**PG&E Response to Request for Additional Information For
 Diablo Canyon Independent Spent Fuel Storage Installation (ISFSI)
 License Application**

Chapter 1. Introduction and General Description

Chapter 2. Site Characteristics

Figure 1 Comparison of Rock and Rock-like Shear wave velocity Profiles with Pleistocene Deposits Velocity Profile along Transport Route

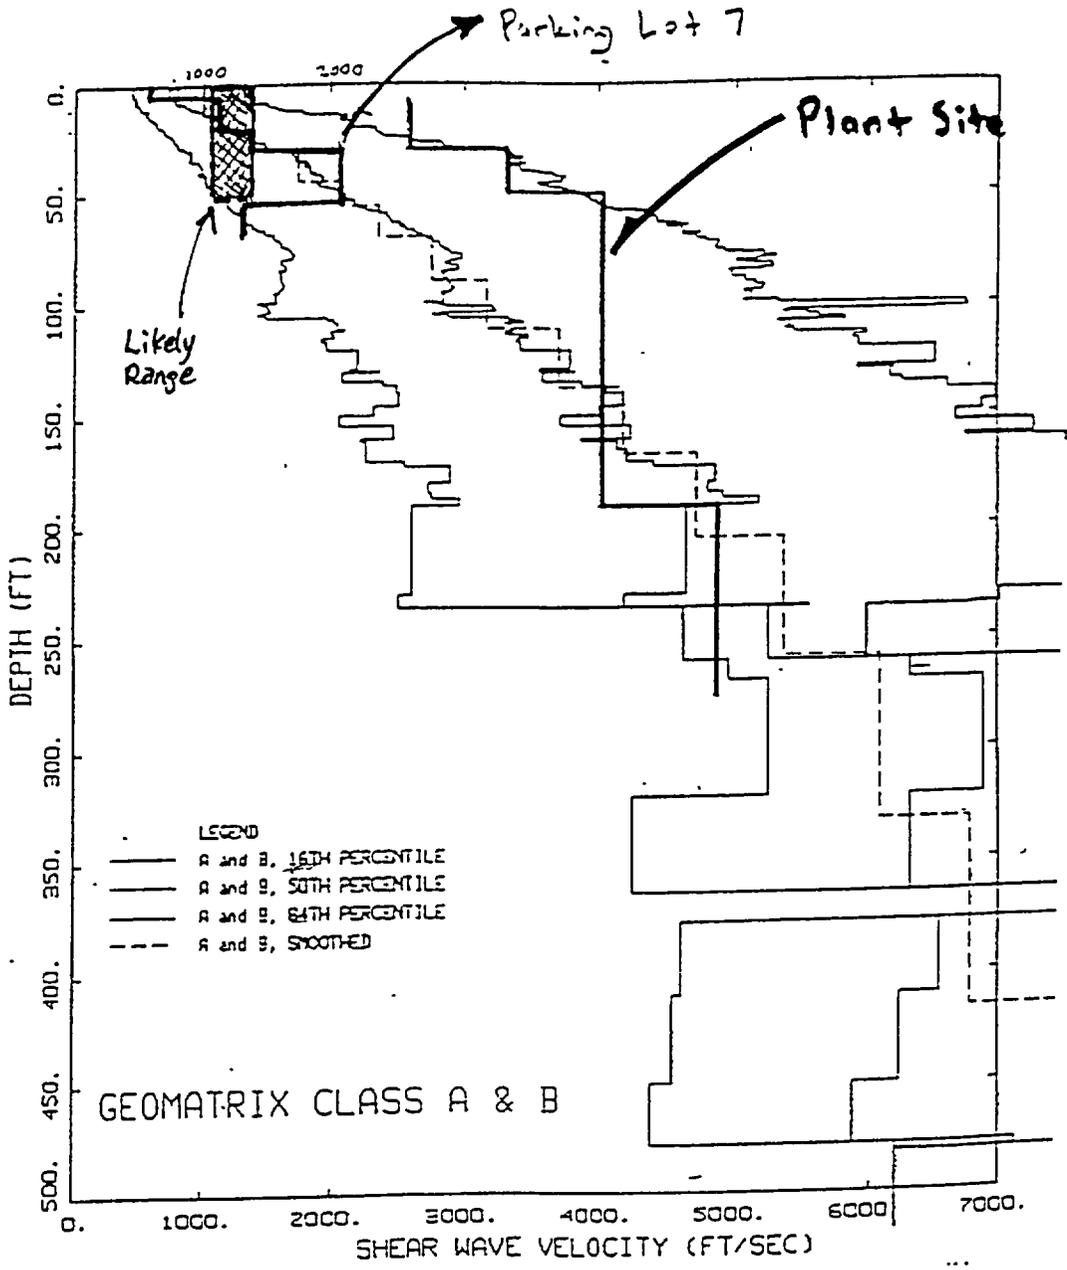
Provide site-response assessment of the vibratory ground motions for the proposed transport route roadway between the nuclear power plant and the Diablo Canyon ISFSI pad; or provide sufficient justification of why a seismic event that may cause cask drop, overturn of the transporter, or sliding of the transporter off the transport route is not credible (as described in Section 8.2.1.2.1 of the Diablo Canyon ISFSI Safety Analysis Report).

Unlike the power plant and the storage-pad locations, which are founded on bedrock, the proposed transport route is underlain by soils and manmade fill. The site response of these soils and manmade fill could change the amplitude and spectral frequency content of the input vibratory ground motions used in seismic design analyses of the transporter and casks. The conclusion provided by the Applicant in Section 8.2.1.2.1 of the Diablo Canyon ISFSI Safety Analysis Report is that the limited exposure time of the radioactive material during transportation from the power plant to the Cask Transfer Facility (12 hr per year, which is equal to a yearly probability of 1.37×10^{-3}), makes this a noncredible accident scenario. This conclusion requires further justification.

The shear-wave velocity profiles of sites classified as either Geomatrix class A or Geomatrix class B which have been used in developing attenuation relations are summarized in Figure 1. This figure shows the median, 16th, and 84th percentile shear-wave profile for rock and rock-like (class A and class B) sites. Also shown on this figure is the range of velocities and depths for the Pleistocene fan deposits along the transport route and one downhole measurement in Parking Lot 7 in close proximity to the transport route. The velocities from the Pleistocene fan deposits are consistent with the velocity profiles measured at rock and rock-like sites.
